Slagel Exhibit 9 – Hankard Surrebuttal

Topic 1 for Surrebuttal

Changed Inputs from Original & Supplemental App to Exhibit 16B

Point 18/R-241

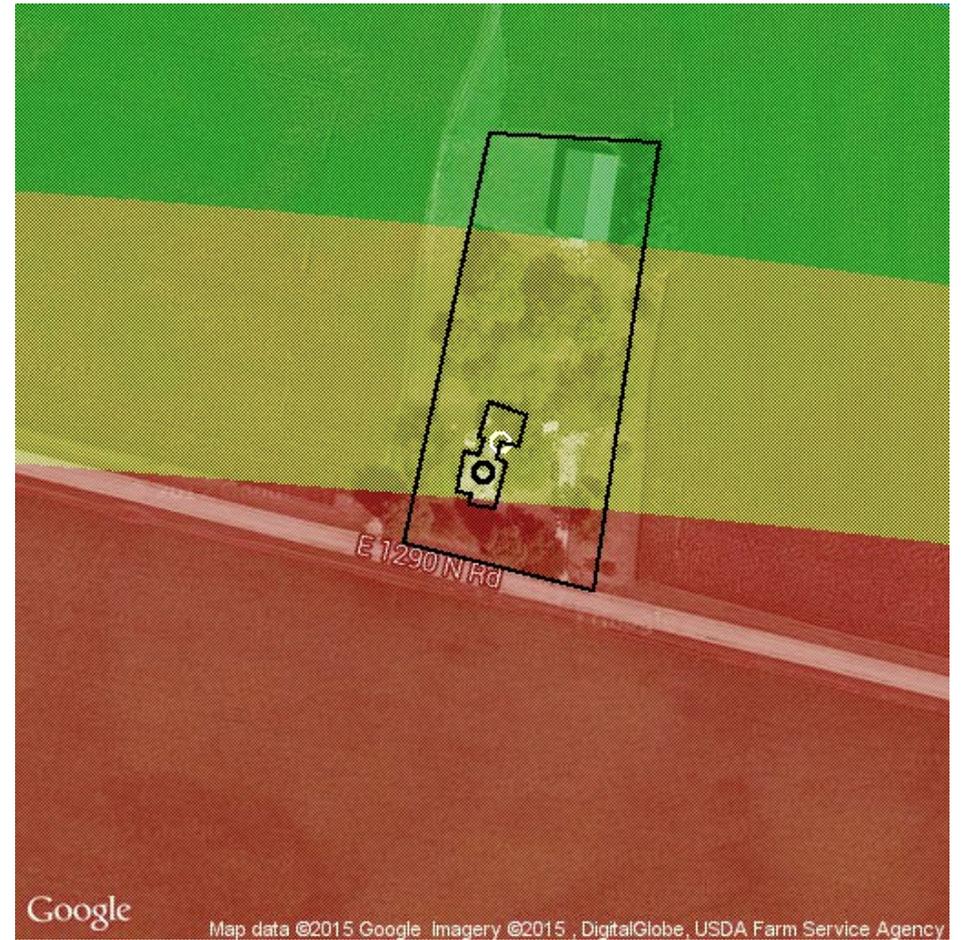
- Red = Over 41 db IPCB nighttime limit @ 1000 Hz
- Yellow = 0-1 db below IPCB nighttime limit @ 1000 Hz
- Green = 1-2 below IPCB nighttime limit @ 1000 Hz
- Black Circle = My Receptor marker (one per home)
- White Circle = PR Receptor marker (one per home)
- Each map is about 760' square, made up of 512x512 pixels. (256x512 point samples)
- Left Side = 24 LNTE GE 1.79-100 configuration using original PR application 1000hz turbine data.
- Right Side = 24 LNTE GE 1.79-100 configuration using the exhibit 16B lowered 1000hz turbine data.
